**Snohomish County
Planning and Development Services**

July 29, 2015

Subject: Point Wells Submittal Drawings—Request for Clarifications

Figure 1 – Typical Tower Floor Plan

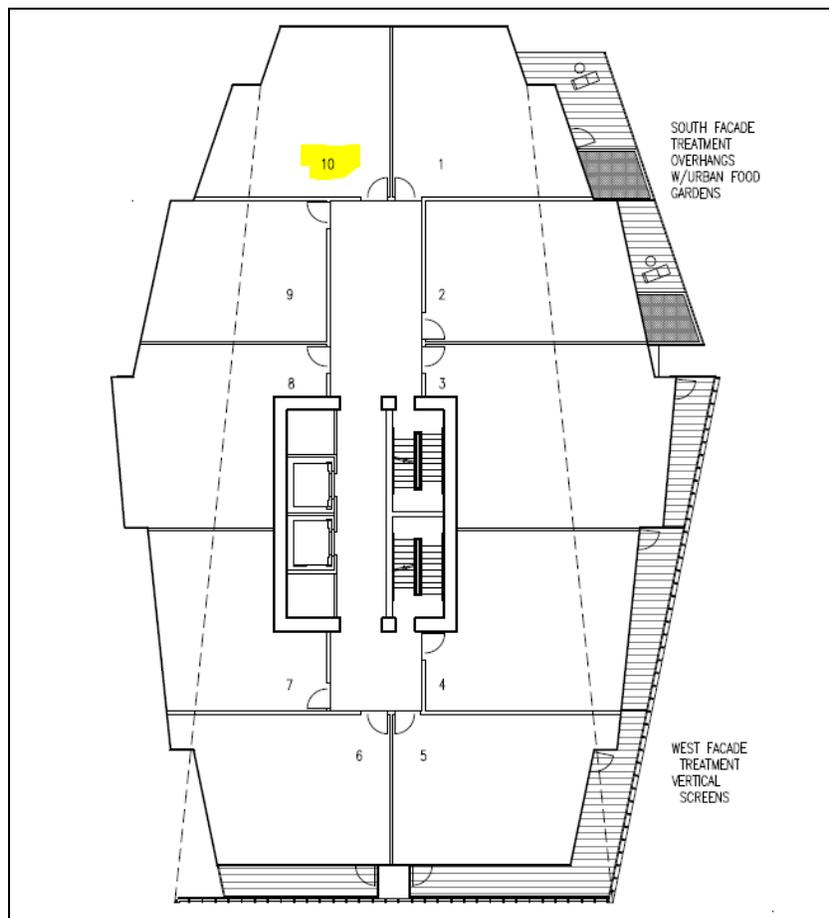
Figure 1 is a portion of Sheet A-300 that shows a typical tower floor plan with 10 units per floor.

Figure 3 shows the data table for the Central Village, including data for building CV-T7. This table indicates that building CV-T7 will have ten floors of residential above the retail podium. Normally, if one builds 10 floors with 10 units per floor as shown in figures 1 and 3, the building would contain 100 total units. However, Figure 3 calculates building CV-T7 as having 108 units based on a rounded estimate of one unit per 1,000 square feet of total residential space (108,300 square feet) in the building. In the same way, the data tables for each phase and for most buildings calculate a different number of units than is implied on the area plans and typical building elevations.

10 floors x 10 units/floor
should = 100 units

The data tables, building elevations and floor plans need to be consistent. If the typical tower floor in the Central Village will have more than 10 units/floor, as implied in Figure 3, then the typical floor plan on sheet A-300 will need revision to reflect this. Alternatively, the table on sheet A-102 could be updated to reflect 10 units per floor. This applies to all towers in the Central Village.

Figure 2 – Footprint for Building CV-T7

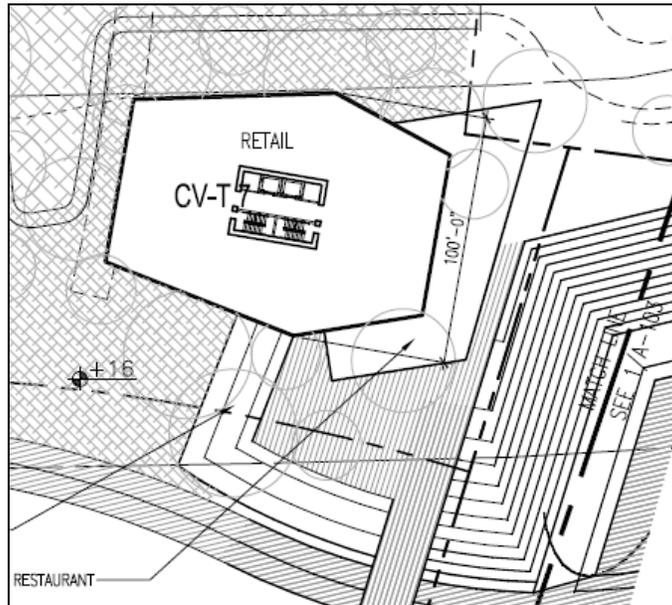
Figure 2 shows from a portion of Sheet A-102 that CV-T7 is clearly a match for the building with the typical floor plan shown in Figure 1.

Figure 4 – Building NV-T2 from Sheet A-101 (Unit Numbers Added)

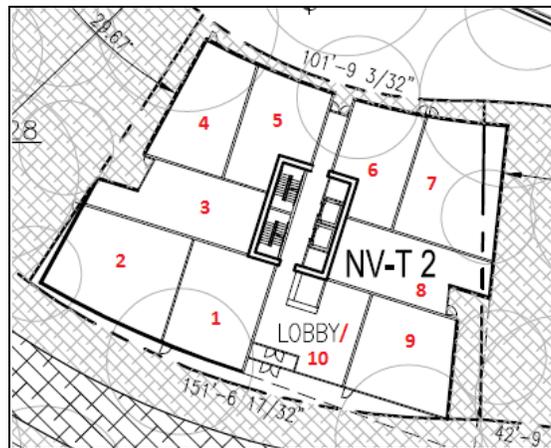
Tower unit counts in other phases need clarification as well. Building NV-T2 in the North Village is an example (see Figure 4, below). This building would appear to have 10 units on each of its upper floors (and only nine on the first floor due to a need for lobby space). With 16 floors proposed, this would suggest 159 units in the building based (10 units per floor minus one unit for the ground floor lobby). However, the data table on from the same sheet (Figure 5, below) would suggest however that the typical floor would have more than 12 units (195 units/16 floors = 12.2 units/floor).

The DEIS will require new sheets detailing the typical tower plans for the North Village, South Village, and Upper Plaza. In addition, please clarify whether the intent of the floor schematics on Sheet A-101 (Figure 4) is to represent the ground floor or upper floors of the towers. The upper floor plans must be different from what appears on Sheet A-101 because only units 1, 5, 6, and 10 have access the elevator and stairs.

Figure 7 – Buildings CV-L1 and CV-L2 from Sheet A-102

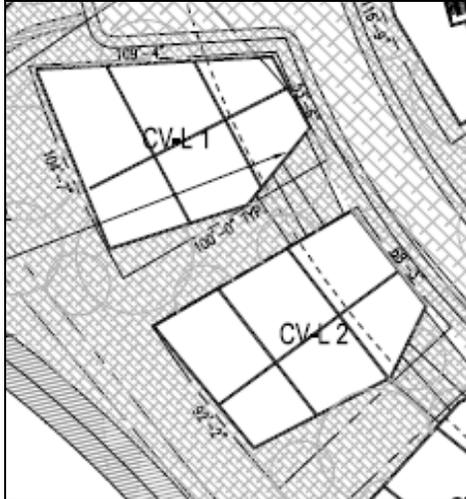
The discussion on townhomes above, however, does not match with how the area plans for each phase depict the buildings and how the units per building are calculated. For instance, Figure 7, next page, appears to show a six-unit design for buildings CV-L1 and -L2. Yet, the data table (Figure 8, also next page) shows 14 units per building. Are these 2-story buildings going to have multi-story townhouse units as suggested by the term and elevation drawing or will the units be stacked flats as suggested in the data tables? Further, either the floor diagrams and or the data tables need revision for internal consistency on the submittal drawings. If the units in these buildings are to be stacked flats, what buildings does Figure 6 depict?

6 or 7 if townhouses,
12 or 14 if flats

Figure 10 – Typical Floor Plan for Midrise Buildings from Sheet A-301

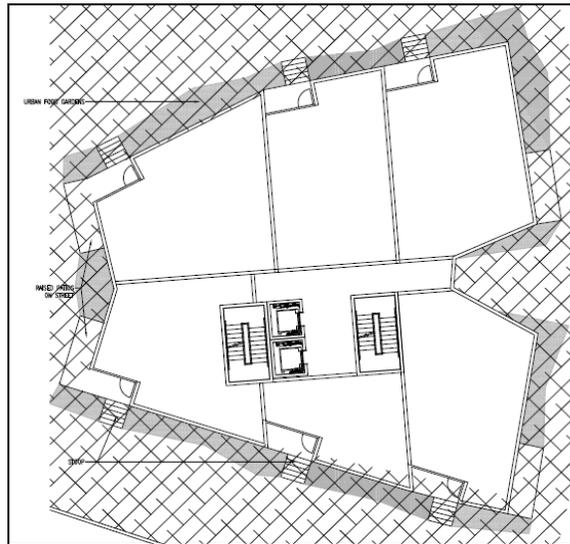
Figure 10, below, shows a typical floor plan for midrise buildings with six units around an elevator core.

Based on Figure 9, we would expect the typical building in Figure 10 to contain 18 units total (units 1-6 being townhomes on floors 1 and 2, units 7-12 being flats on floor 3, and units 13-18 being smaller flats on floor 4). This expectation, however, is not what appears on the data table

Should this be 18 units per 4-story building?

Figure 12 – Building Area vs Leasable Area Illustration and Questions from Sheet A-300

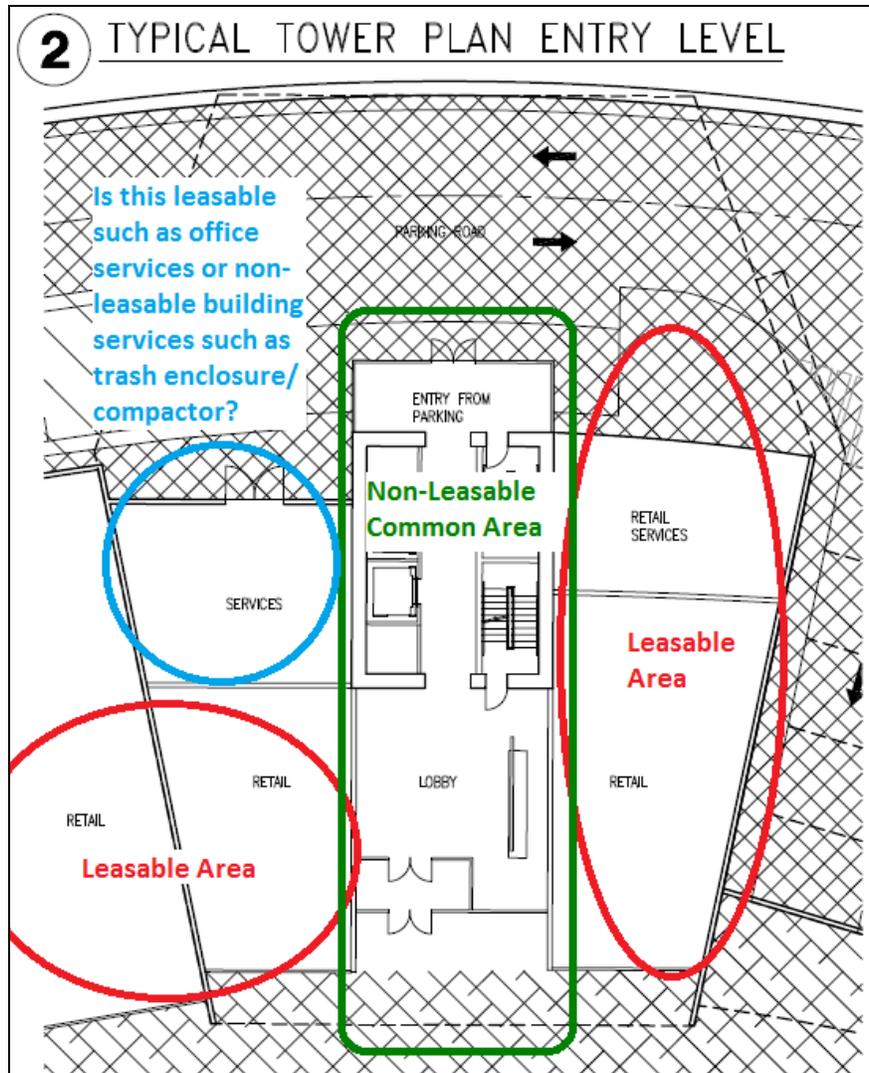
The leasable area is the basis for trip generation in the traffic modeling. Leasable area is the building area minus things like lobbies and elevator space. Please revise existing drawings and add new drawings to identify the square footages and uses proposed for non-residential building areas, clarifying certain areas such as shown in Figure 13 below.
